B22002 Campus Police Renovation

Addendum #3

TO: Prospective Bidders
SUBJECT: Addendum No. 3
PROJECT NAME: Campus Police Renovation
JJC PROJECT NO.: B22002

Joliet Junior College
Campus Police Renovations
Architect's Project Number: 220120.00

DEMOLITION PLAN

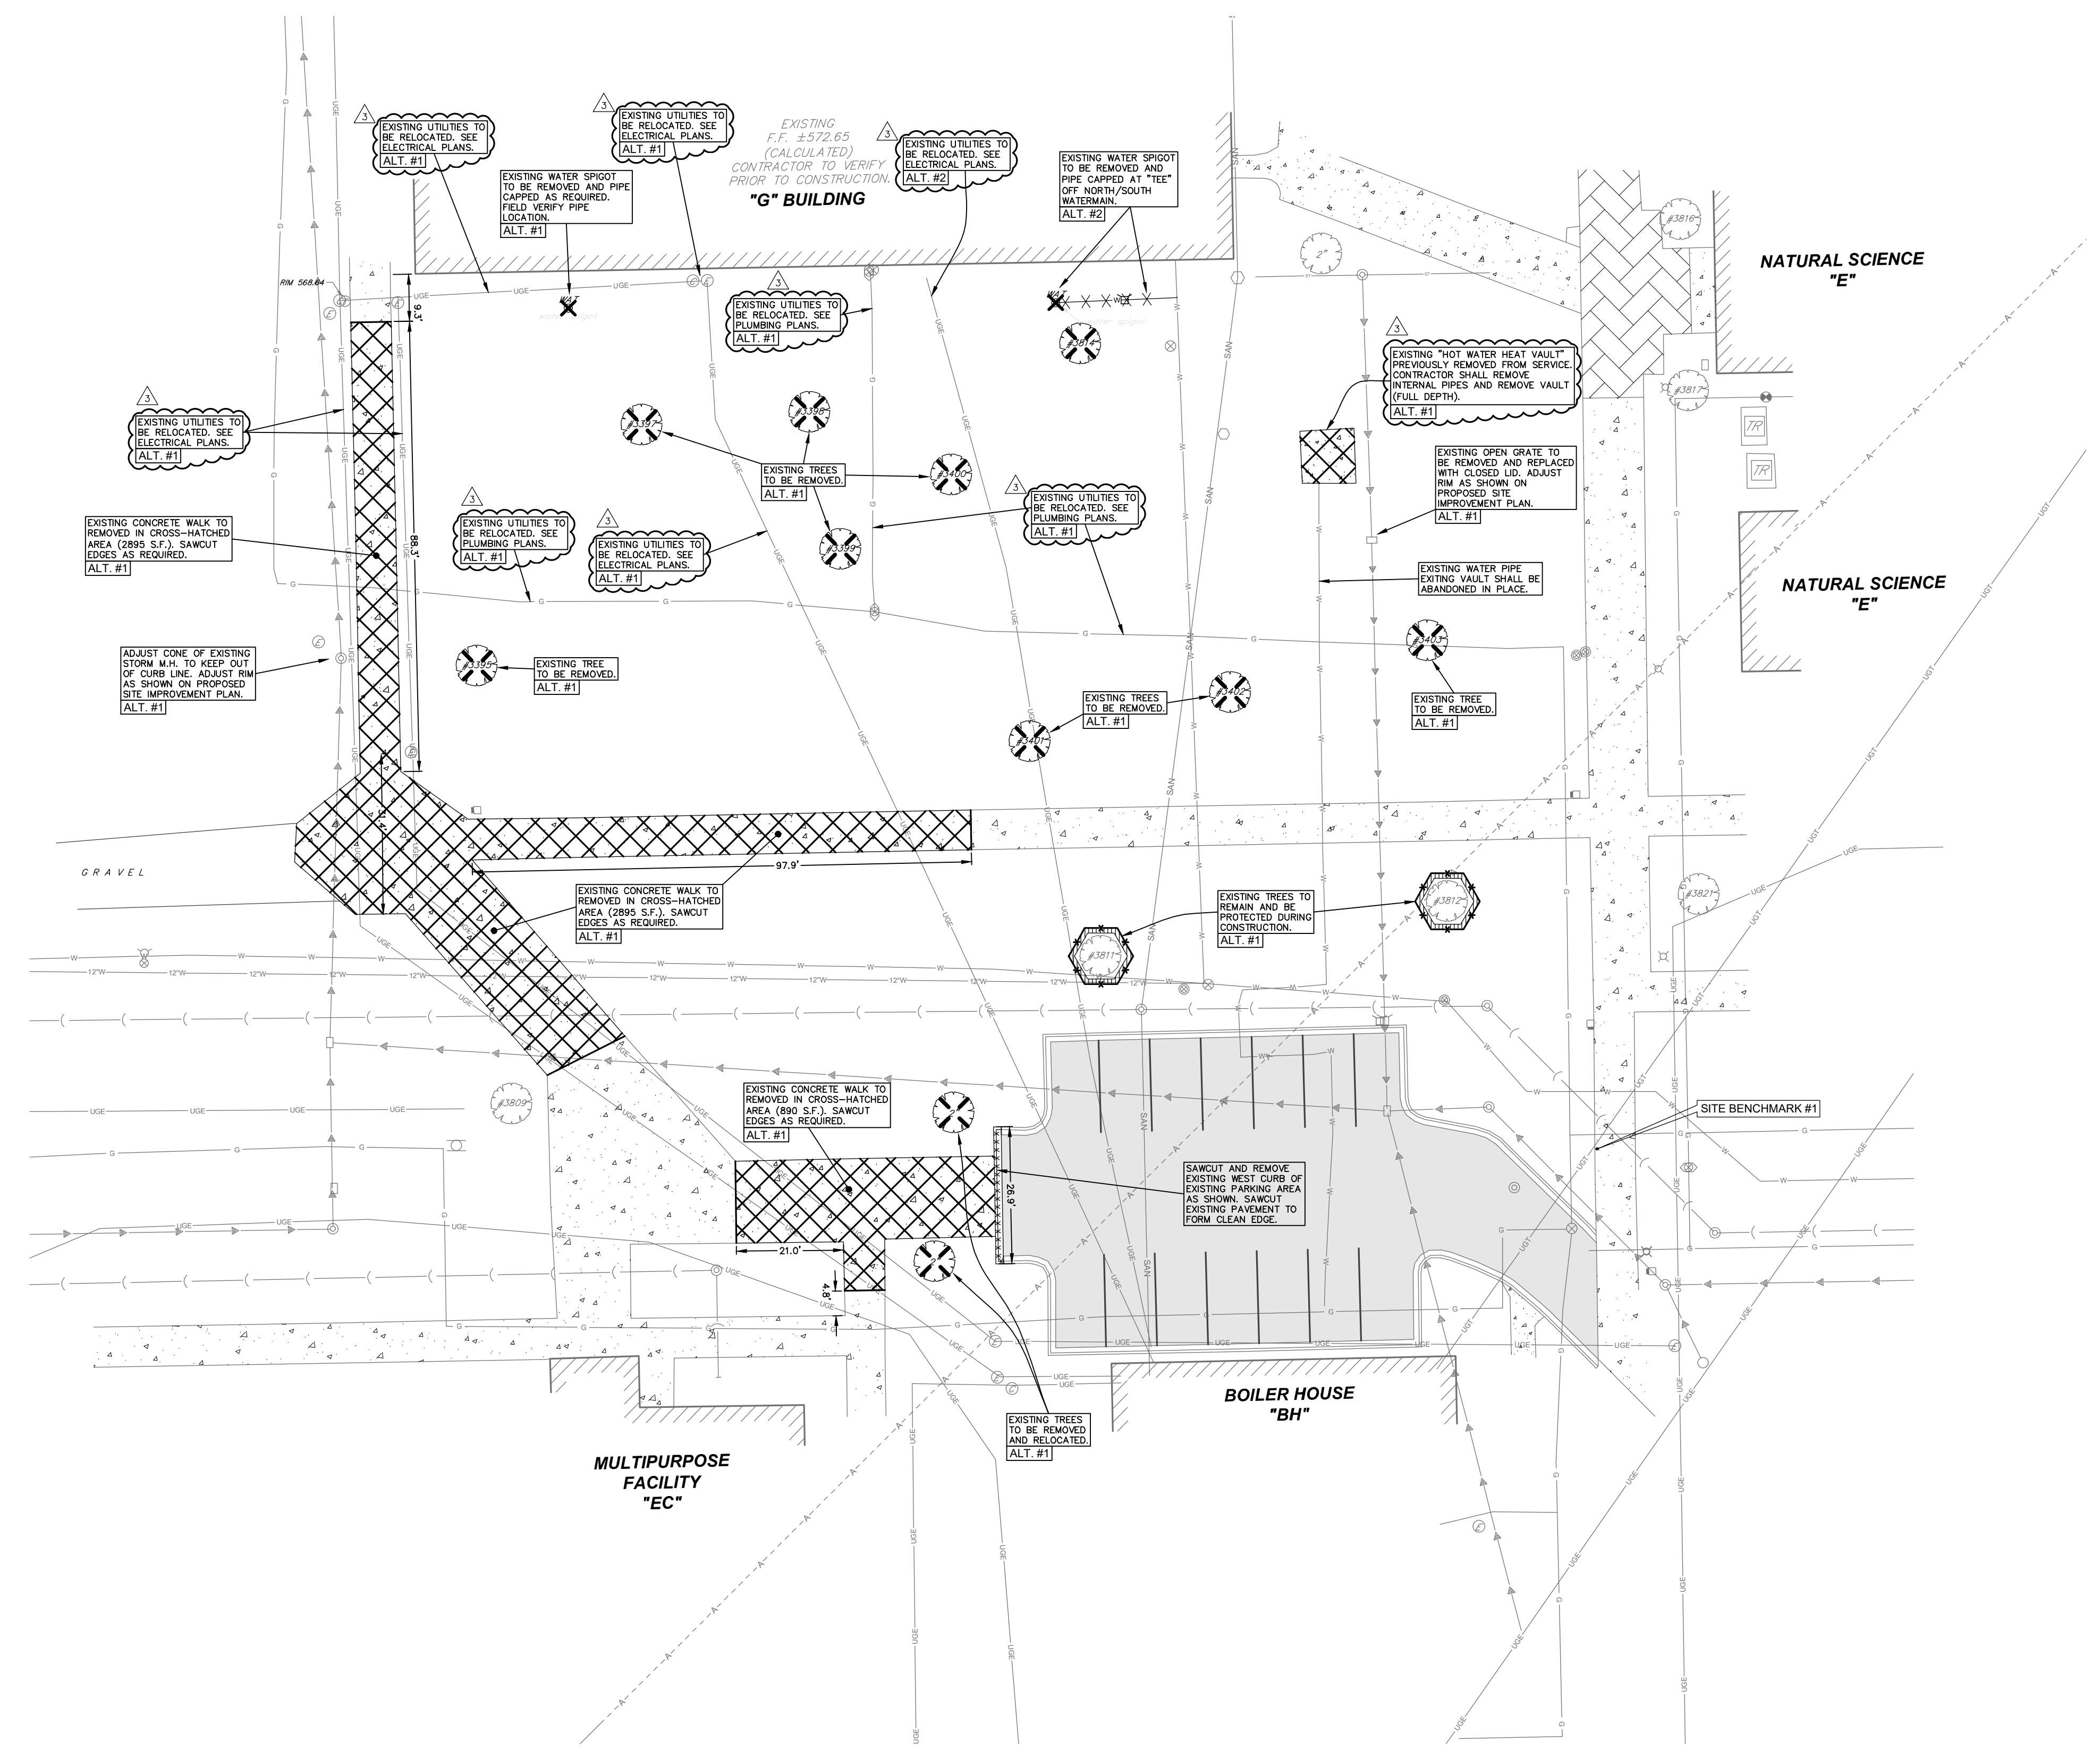
- A. *Correct, the existing building is not sprinkled.*
- Q. On sheet CD101 it indicates existing water spigots to be removed and pipe capped. What bid package is responsible for these items?

- A. *Plumbing Trades Contractor.*
- Q. On sheet CD101 it indicates for the existing hot water heat vault to be removed. What bid package is responsible for this item?

- A. *All bid packages are due at the same day and at the same time. MEP packages will not be opened prior to General Trades Package.*
- Q. There is a note on sheet CD101 stating: "Existing "Hot Water Heat Vault" previously removed from service. Contractor shall internal pipes and remove vault (full depth). This note is confusing, please clarify.
